Issue List

05-29-23 CULVERS - GRAIN VALLEY, MO

PRV3hinge
05/22/2023

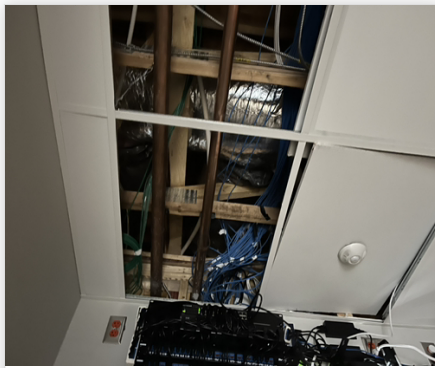
Issue Name : PRV3 cannot be raised up to look down grease duct
Description : PRV3 hinge kit is installed on the same side as the conduit pipe which is preventing the unit from leaning back. Hinge kit needs to be installed on the opposite side of the grease spout. This will prevent duct cleaning and getting unit pressure.
Created By : National TAB **Assigned To :** National TAB - Jacob Davidson
Status : Open
Originated Date : 05/22/2023 - Jacob Davidson - National TAB

Takeoff
05/23/2023

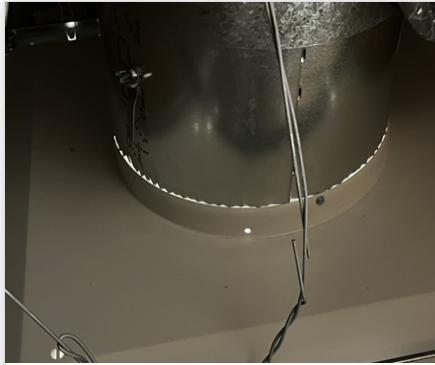
Issue Name : RTU2 diffuser 2-16 very low on flow, takeoff not accessible
Description : Diffuser 2-16 on the GRD for the electrical room is very low on flow at 124 of 600 CFM. This value hasn't changed with moving air around which implies the damper is closed at takeoff, however tech is unable to reach takeoff to check for a damper due to ceiling restrictions.
Created By : National TAB **Assigned To :** National TAB - Jacob Davidson
Status : Open
Originated Date : 05/23/2023 - Jacob Davidson - National TAB
